Access Compliance Report

Public Rights-of-Way

Intersection ID: 2988	Main Street: WAVERLY LYNN LN	Cross Street: THOMAS RIDGE DR	Location: SE
ADA ID: EBBE331C0946	Ramp Type: PerpDiag	Initial Pass/Fail: Fail	Overall Compliance: No
		Severity Score: 35

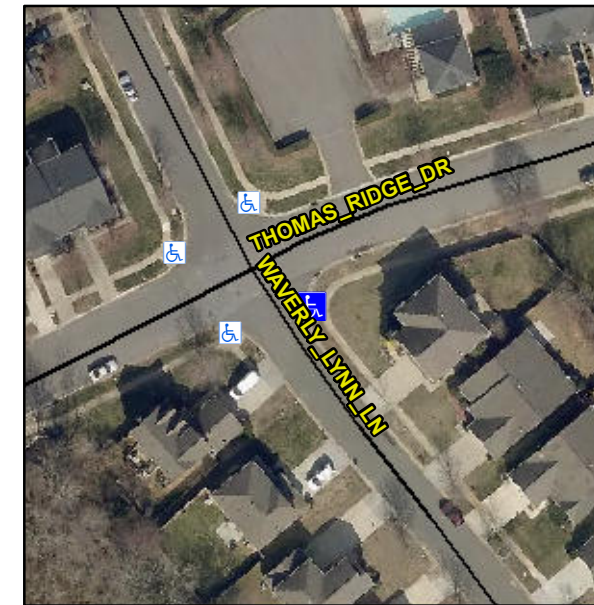
Not Found, R304.5.1

Compliance	Description	Data	Compliance	Description	Data
N/A	Ramp Length (in)	130.5	Yes	Ramp Slope (%)	5.5
No	Ramp Width (in)	31.0	Yes	Ramp XSlope (%)	2.0
N/A	Flare Type LT	N/A	N/A	Flare Type RT	N/A
N/A	Flare Slope LT (%)	N/A	N/A	Flare Slope RT (%)	N/A
N/A	Flare Traversable LT?	N/A	N/A	Flare Traversable RT?	N/A
N/A	Landing Length (in)	N/A	N/A	DWS Provided?	N/A
N/A	Landing Width (in)	N/A	N/A	DWS Contrast?	N/A
N/A	Landing Slope (%)	N/A	N/A	DWS Length (in)	N/A
N/A	Landing X Slope (%)	N/A	N/A	DWS Full Width?	N/A
N/A	Landing Curb? (Y/N)	N/A	N/A	DWS Offset (in)	N/A
N/A	Shared Landing?	N/A			
N/A	Gutter Ponding?	N/A	N/A	Gutter Slope (%)	N/A
N/A	Gutter Lip Ht (in)	N/A	N/A	Gutter X Slope (%)	N/A
N/A	Painted X Walk1?	No	N/A	Painted X Walk2?	No
	X Walk 1 Direction	To N		X Walk 2 Direction	To W
N/A	X Walk 1 Width (in)	N/A	N/A	X Walk 2 Width (in)	N/A
	X Walk 1 Slope (%)	2.6		X Walk 2 Slope (%)	2.2
	X Walk 1 X Slope (%)	3.7		X Walk 2 X Slope (%)	1.9

Remove & Replace Curb Ramp With Two New Directional Ramps or Equivalent.
